MUNCIE POWER PRODUCTS

Product Bulletin #00136

Subject: FR6Q Solenoid Valve & Rear Cover Update

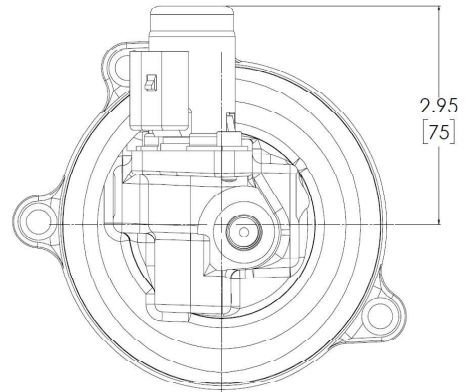
A change has been made to the FR6Q Series solenoid valve and rear cover, which will allow for improved installation clearance on certain Ford F-650 and F-750 gas engine applications. This change applies to all non-Muncie Start® units built on or after February 21, 2025.

Previously, there was an interference between the electrical connector on top of the solenoid valve and an exhaust hanger bracket connected to the transmission. The new solenoid valve is approximately 0.6" shorter, which provides the necessary clearance. A rear cover change was required in order to accommodate the new solenoid valve.

Solenoid valves must be matched to the correct rear cover. New solenoid and cover P/Ns are 35T40860 and 15T42720, respectively. Old solenoid and cover P/Ns are 35T43600 and 15T62484. The new solenoid valve is not compatible with the old cover, and vice versa. Refer to service parts manual SP16-04 for more information.

Old solenoid valve and rear cover
Units built before 2/21/2025

New solenoid valve and rear cover
Units built on or after 2/21/2025
